Initial Study and Mitigated Negative Declaration

**Water Reclamation Plant No. 7 (WRP 7) Phase 1
Non-Potable Water Improvements Project**

City of Indio, California

September 2023

Figure 6. Biological Survey Results

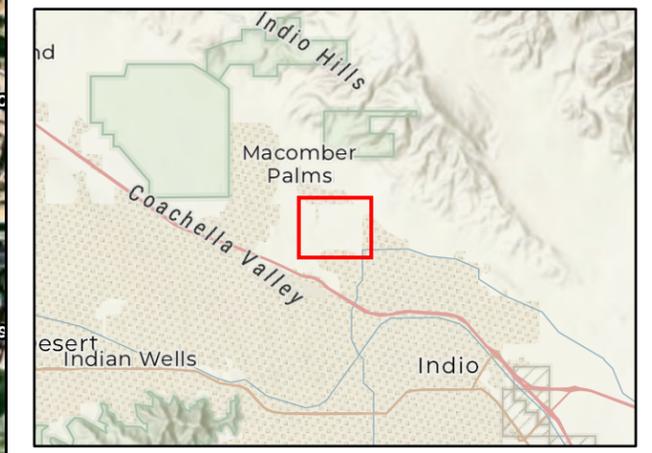
Page 4-31 of the MND indicates that “one burrowing owl was observed within the Project Area at a burrow located on the wall of one of the water basins (Figure 6). Burrowing owl sign in the form of whitewash was present at the burrow entrance. Additionally, the Project Area contains suitable habitat, and multiple suitable size burrows were observed during the biological survey. The areas in the vicinity could also provide suitable foraging habitat as well as breeding habitat for burrowing owl.” Although the MND includes Mitigation Measures BIO-3 and BIO-PS-1 for burrowing owl, CDFW considers these measures to be inadequate in scope and timing to reduce impacts to less than significant. CDFW recommends that CWWD replace Mitigation Measures BIO-3 and BIO-PS-1, with the following mitigation measure:

BIO-PS-1: Burrowing Owl Presence/Absence. If, during the pre-construction Burrowing Owl Surveys, burrows onsite are determined to be unoccupied, construction may proceed without the preparation of a Burrowing Owl Plan. If the surveys determine the presence of burrowing owls, a Burrowing Owl Plan consistent with the guidance in the CDFW Staff Report on Burrowing Owl Mitigation (CDFW 2012) shall be prepared and implemented. The Burrowing Owl Plan shall describe proposed avoidance, minimization, mitigation, and monitoring actions. The Burrowing Owl Plan shall include the number and location of occupied burrow sites, acres of burrowing owl habitat that will be impacted, details of site monitoring, and details on proposed buffers and other avoidance measures if avoidance is proposed. If impacts to occupied burrowing owl habitat or burrow cannot be avoided, the Burrowing Owl Plan shall also describe minimization and relocation actions that will be implemented. Proposed implementation of burrow exclusion and closure should only be considered as a last resort, after all other options have been evaluated. If impacts to occupied burrows cannot be avoided, information shall be provided regarding adjacent or nearby suitable habitat available to owls along with proposed relocation actions. ~~mitigation in accordance with the CDFW shall be implemented as follows:~~

~~If passive relocation actions~~ If burrowing owls are identified as being resident onsite outside the breeding season (September 1 to February 14) are determined to be necessary, coordination with CDFW will occur prior to the initiation of relocation activities, ~~they may be relocated to other sites by an approved permitted biologist (permitted approved by CDFW) or passive relocation in coordination with CDFW, as allowed in the CDFW Staff Report on Burrowing Owl Mitigation (CDFW 2012).~~
